U.S. Department
of Transportation
**Federal Highway
Administration**

In Reply Refer To:
HSA-10/WZ-226

Thank you for your letter of December 7, 2005, requesting the Federal Highway Administration (FHWA) acceptance of the addition of Alpolic signs to your company's Type II Plasticade and Fibercade barricades as crashworthy traffic control devices for use in work zones on the National Highway System (NHS). Accompanying your letter was a testimonial from Korman signs agreeing to the use of their crash test results to validate the performance of the sign/barricade combination. You requested that we find these devices acceptable for use on the NHS under the provisions of National Cooperative Highway Research Program (NCHRP) Report 350 "Recommended Procedures for the Safety Performance Evaluation of Highway Features."

Figure 36. Details of the Plasticade Products Plasticade Type II A-Frame barricade.

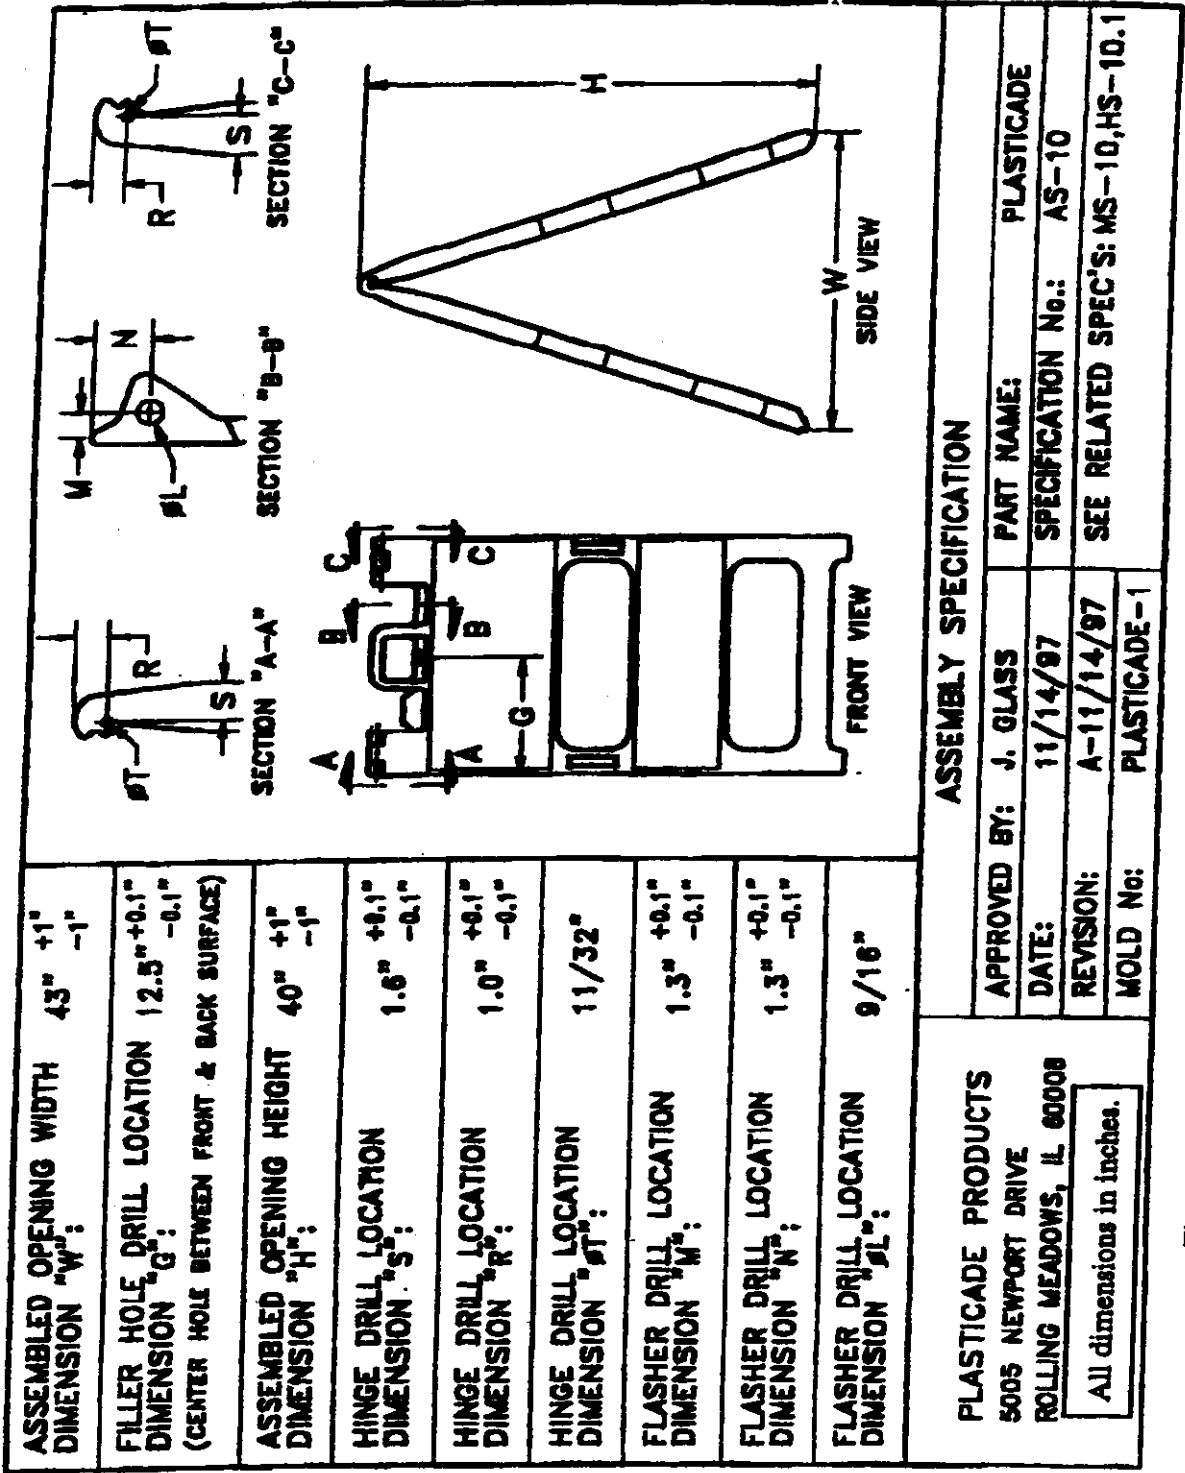
After reviewing the crash testing conducted on your company's Plasticade and Fibercade barricades, the Type II barricade sign stands of Korman Inc., and the discussion provided by Korman on the use of the Alpolic material on Type II barricades we concur in your request to use 48 x 48 inch Alpolic signs on these barricades. The Alpolic material has been tested in various orientations and, even with direct high-speed impacts on windshields, there is only moderate damage with little or no potential for occupant compartment intrusion.

The Plasticade and Fibercade Type II barricade sign supports described above and detailed in the enclosed drawings are acceptable for use on the NHS under the range of conditions tested, when proposed by a State. The Alpolic signs will be affixed to the top rail of the Plasticade and Fibercade barricades using bolts or pop rivets. Signs on the Plasticade will also be secured by the sign sleeve.
